PLANNING UNIT REPORT  
DEPARTMENT OF PLANNING AND DEVELOPMENT  
September 12, 2006

**ZONING MAP AMENDMENT, I.D. 04209 TO REZONE 309 WEST WASHINGTON AVENUE/33 SOUTH BROOM STREET FROM PUD-SIP TO AMENDED PUD-SIP:**

SUBJECT: **309 West Washington revised**

Detail

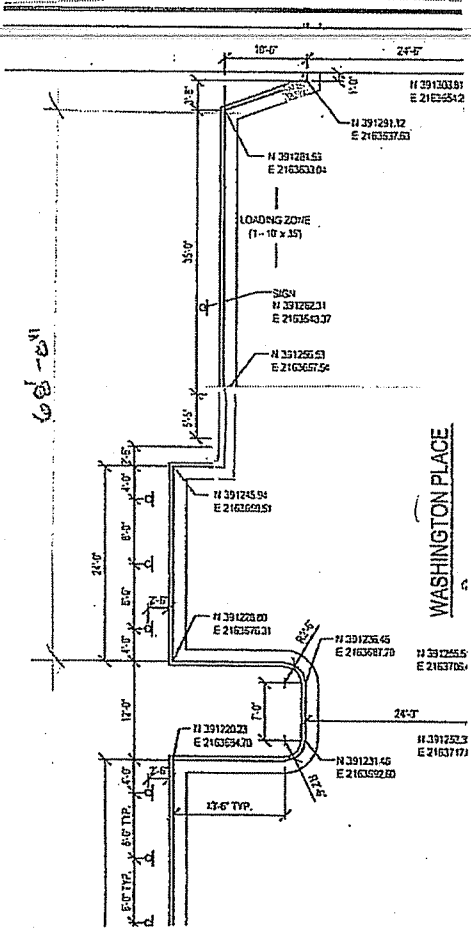
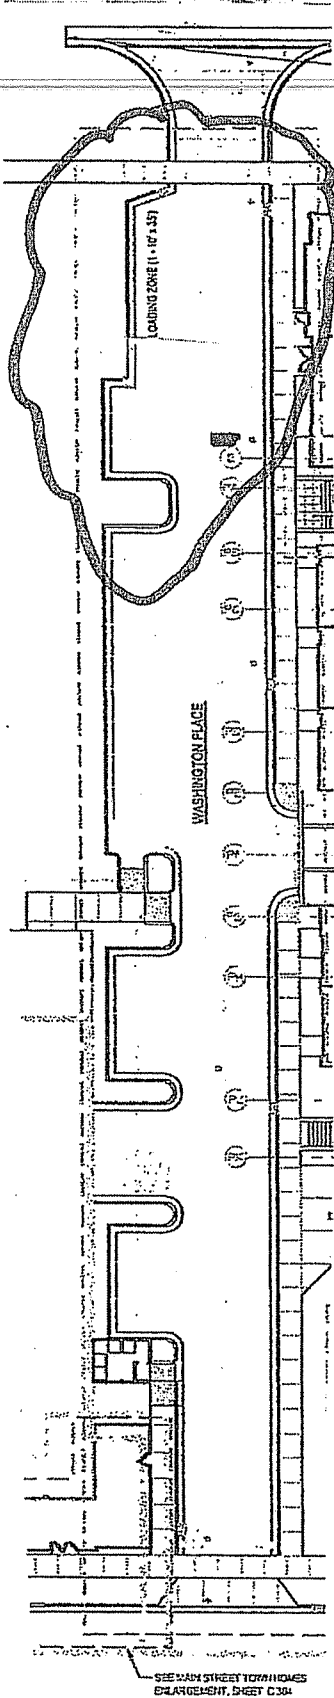
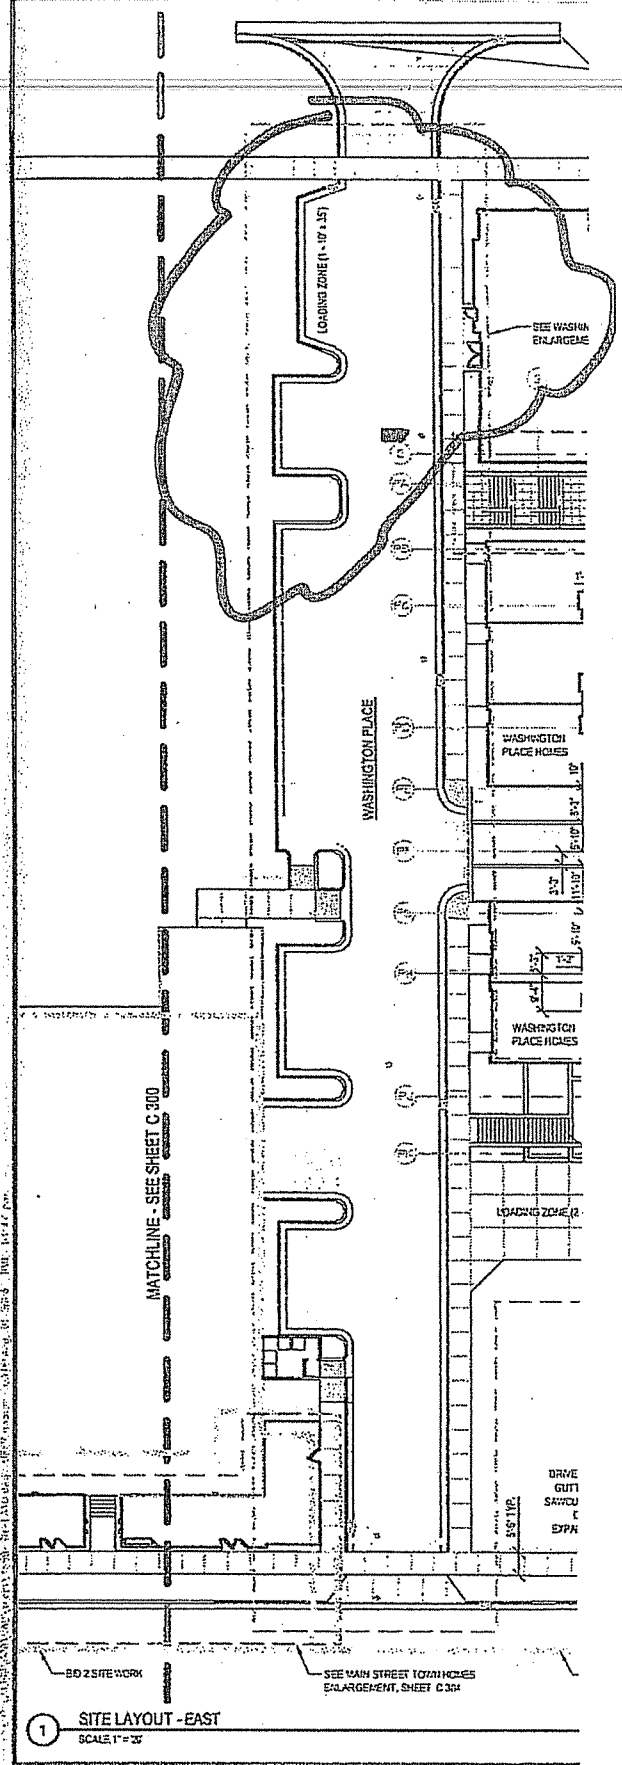
1. The applicant should be required to fulfill the requirement of Condition #56 of the GDP approval by providing an off street loading area for large delivery vehicles such as semi tractor moving vans. Such can be accommodated on Washington Place as shown on the accompanying diagram.

Proposed Large Truck Loading Zone  
68' x 10'

Current loading zone 30' x 10'
